MEMORANDUM

RE: Public Hearing: McDonald's Restaurant Request for an Amendment to Their Special Use and Approval of New Menu Boards Pursuant to Article 9.02B.14 (a) of the Deerfield Zoning Ordinance.

July 10, 2019 - ARC Meeting Summary

July 10, 2019 - ARC Meeting Minutes

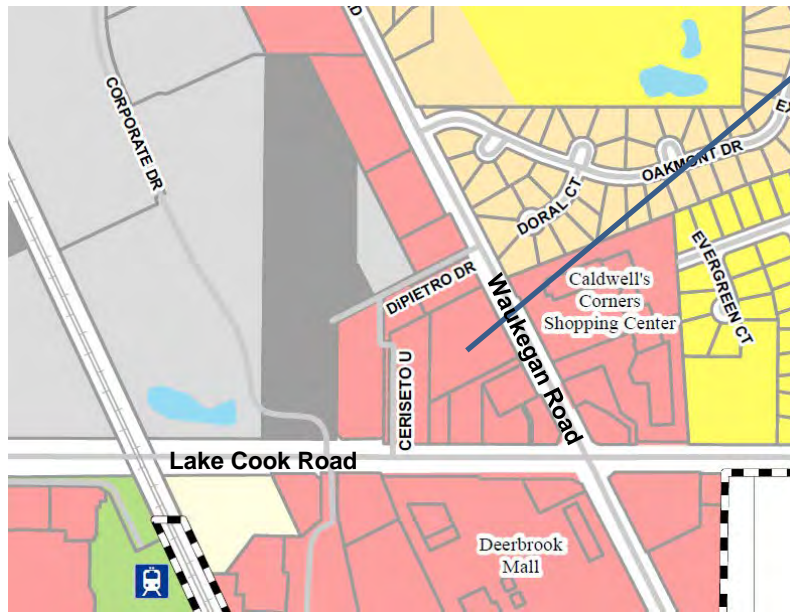
Amanda Stengel, Director of Design with Bartaco and Chris Siavelis with CRM Properties were present. Mr. Siavelis explained Bartaco was purchased by Del Friscos last year, and the new management team is requesting the changes. They would like to add two (2) fabric awnings on the north and south elevations. The color will be Captain Navy, which is used for the restaurant's interior fabric. Ms. Flores noted that the awning color appears to be different from the sign color. Ms. Stengel confirmed that they are different colors. Ms. Flores would like to see the colors match. Mr. Siavelis noted they want to add matching blue paint to the brick border around the north and south signs.

Mr. Siavelis noted they would also like to add standalone heaters for the outdoor patio. He noted Bobby's has similar heaters. Ms. Schneider expressed concern, because there is a lot going on in the patio. Mr. Siavelis explained the standalone heaters would be located outside the canopy while the suspended heaters are under the canopy. He explained they would like to add a sconce to the west of the door. Ch. Dunn noted the sconce is different from the other fixtures on the building. Mr. Siavelis noted they propose adding insect screens. The proposed screens are retractable and have a built-in housing that blends into the elevation. Ms. Stengel explained the screens are electronically controlled.

The Commissioners discussed the proposed paint for the brick border. The paint will match the existing Bartaco logo, which is different from the awnings. Mr. Siavelis explained all the painting will be the same color while the awnings will be a different blue color. The Commissioners believe the brick border will look better painted.

The Commissioners discussed the proposed awnings. Ms. Stengel will look into making the awnings and paint color match, as specified on the drawings. The Commissioners would like to see a paint sample. Ms. Chaitman noted if the paint is changed to match the awning, it would not be the same as their logo color. Ms. Flores suggested they bring a copy of their logo on printed material when they return.
